Remarks/Arguments

In the response to the Office Action dated September 16, 2005, in the second paragraph, applicants noted that the objections to the drawings under 37 CFR § 1.83(a) and the claims under 35 USC § 112 in Paragraphs 1-5 of the Office Action have been fully addressed in a petition to the Commissioner accompanying the September 16th response. In Paragraph 4 of the Office Action, Claims 1-5, 7, 9, 10, 14 and 15 were rejected under 35 USC § 112, first paragraph, as failing to comply with the enablement requirement. The Examiner asserted that the claims contain subject matter which was not described in the specification in such a way as to enable one skilled in the art to which it pertains, or with which it is most nearly connected, to make and/or use the invention. More particularly, the Examiner asserted that the disclosure and claims refer to a relative difference in size of the fuel element contact area, between the contact area of the “first set of dimples and/or springs” versus the contact area of the “second set of dimples and/or springs”. In this regard, the Examiner asserted:

FIG. 6

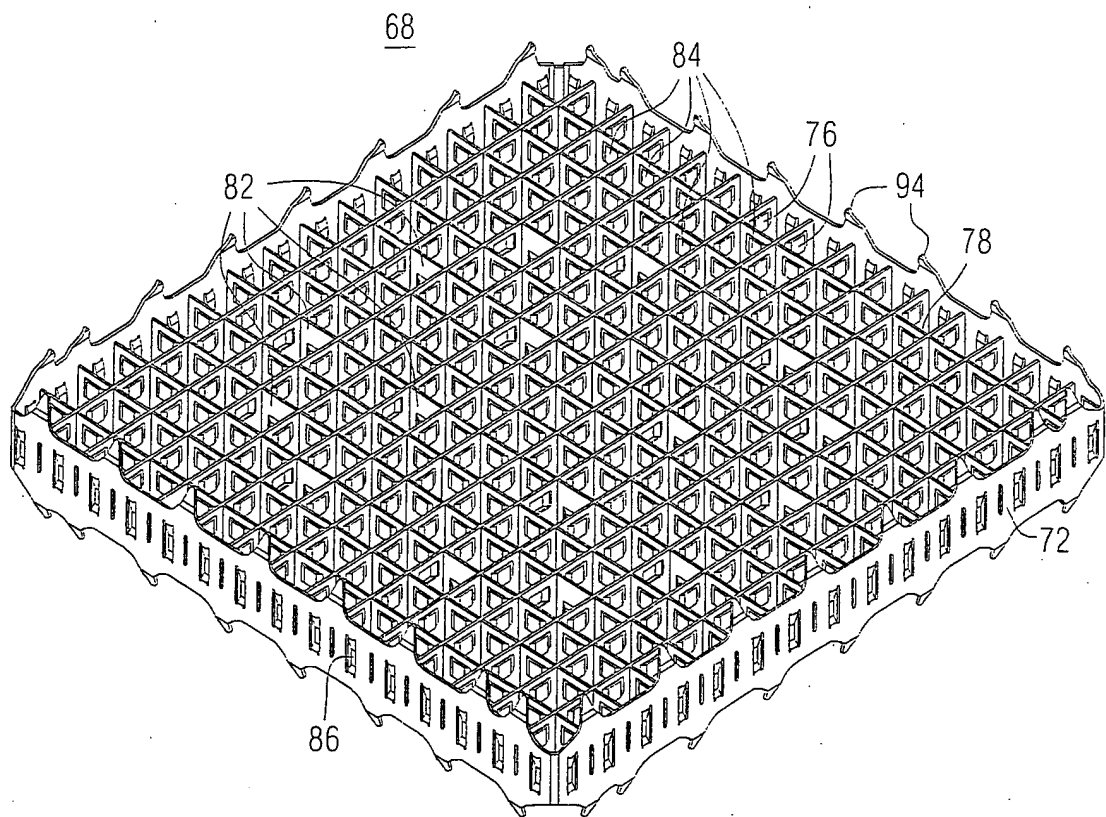
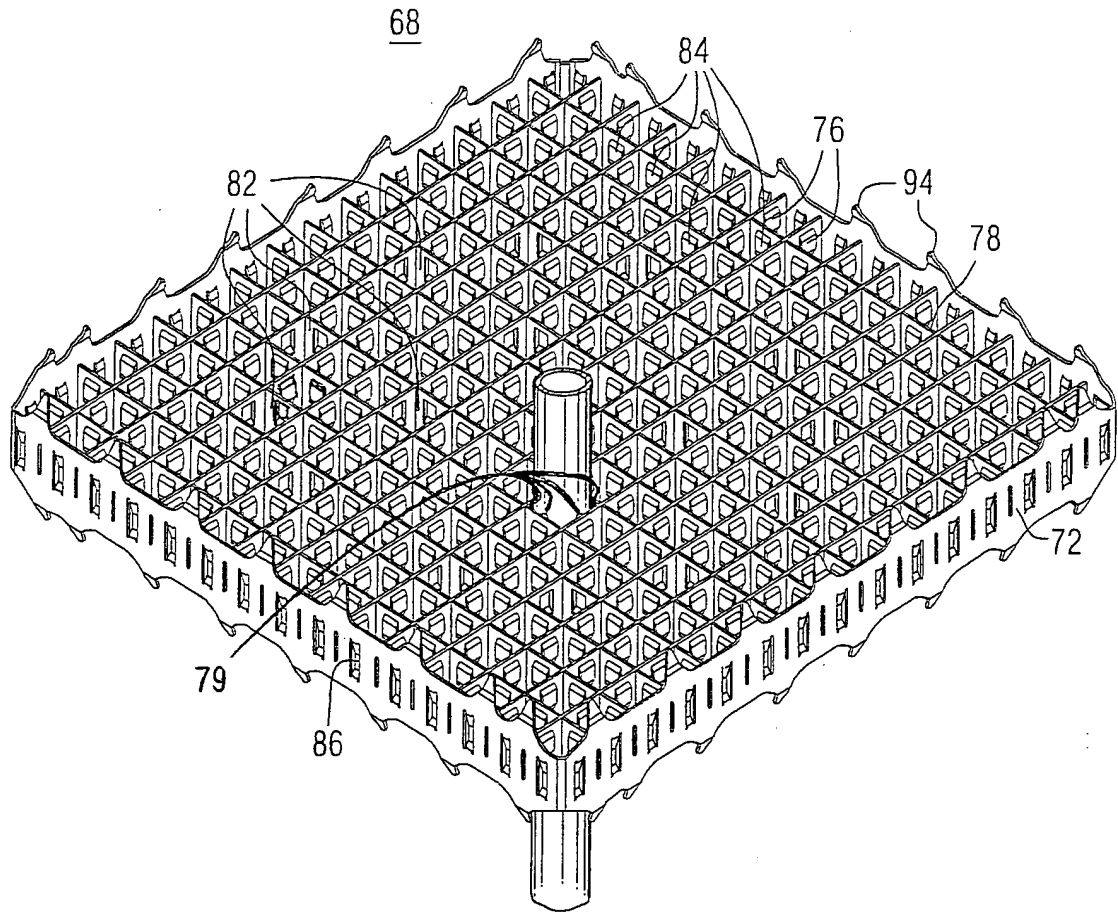
It is immaterial as to whether Fig. 6 shows the outer strap of the auxiliary grid as having vertical springs because the claimed relative difference in contact area of the dimples and/or springs, is with the inner straps of the two different grids (e.g. see the specification on page 11 lines 29+).

Despite applicants arguments to the contrary, it is not seen wherein Fig. 6 shows both vertical springs and dimples on the inner straps nor does it show a common plane intersecting both the vertical springs and the dimples.

Amended Fig. 6 does not clearly show a guide tube attached at the cell corners by butt-welds (it is not known what the slightly darkened portions at the two illustrated diagonal corners of the cell (through which the guide tube passes) is supposed to represent).

While applicants Fig. 6 shows vertical springs on the outer strap of the auxiliary grid, it does not show vertical springs on the inner strap (the inner strap only shows a horizontal dimple at the upper end of the cell wall).

Despite applicants arguments to the contrary, it is not seen wherein Fig. 6 shows both vertical springs and dimples on the inner straps nor does it show a common plane intersecting both the vertical springs and the dimples.

In a response mailed February 22, 2005, applicants amended Fig. 6 (attached hereto as Exhibit C) showing the welds attaching the control rod guide tubes to the grid cell in a more pronounced fashion and labeling them with reference character 79. Reference character 79 was also added to the corresponding description in the paragraph spanning pages 11 and 12. Fig. 6 was also amended to better show that the springs in the grid cells that have springs, i.e., fuel rod support cells, are co-planar and are oriented in the vertical direction. Support for both of these changes can be found on page 11 of the specification. The specification was additionally amended to correct the reference to Figs. 4 and 6 in the paragraph beginning on page 9, line 24. It should be clear from the figures that Fig. 6 illustrates a 15x15 array and Fig. 4 shows a 17x17 array. In the Remarks/Arguments section of the response of February 22nd, applicants identified that they disagreed with the Examiner that the drawings did not show the relative size of the contact areas of the dimples and/or springs of the auxiliary support cells versus the main support cells, and that the features of Claims 9 and 13 were not shown. However, for the sake of advancing prosecution, applicants have further amended Fig. 6 to clearly show that the dimples and/or springs are on the vertical and they are all within the same plane. Applicants directed the Examiner’s attention to Fig. 5, which shows the springs of the traditional grid on a diagonal with the contact area shown relative to the width of the cell as being substantially less than that shown for the vertical springs and dimples shown in Fig. 6 relative to the cell wall width illustrated in Fig. 6. In support of this proposition, applicants cited the Federal Circuit opinion in *Hockerson-Halberstadt Inc. vs Avia Group International, Inc.* (222 F.3d 951, 956, and 55 USPQ F.2d 1487, 1491, Federal Circuit 2000) which stated: “It is well established that patent drawings do not define the precise proportions of the elements and may not be relied on to show particular sizes if

On May 5, 2005, applicants submitted a Request for Continued Examination and entry of an amendment enclosed therewith, which modified Fig. 6 (attached hereto as Exhibit D) as previously amended as shown in Exhibit C attached herewith and discussed with the Examiner during the telephone interview. The amendments to the specification were essentially those previously submitted but not entered with the amendment of February 22nd. Claim 1 was additionally amended to make explicit an inherent limitation previously in the claim wherein the auxiliary grid is supported between two main support grids without any other auxiliary grids between the auxiliary grid and the adjacent main support grid. Claim 13 was cancelled as previously noted. The arguments in support of the drawings were essentially those previously submitted in the amendment of February 22nd that had not been entered.

Applicants are at a loss as to what the Examiner is referring to, because the amendment provided to Fig. 6 in Exhibit D, which accompanied applicants' Request for Continued Examination, clearly shows the springs and/or dimples on the inner straps in a vertical orientation, all on the same plane. 37 CFR § 1.83(a) provides:

It is respectfully asserted that applicants have complied with this requirement. In Paragraph 2 of the Office Action, the Examiner has asserted that Fig. 6 (in Exhibit D) has not been approved as it is drawn to new matter. It is respectfully asserted that the amendments to Fig. 6 were merely made to conform the drawings to the description in the specification as quoted above. Therefore, the same should not be considered new matter.
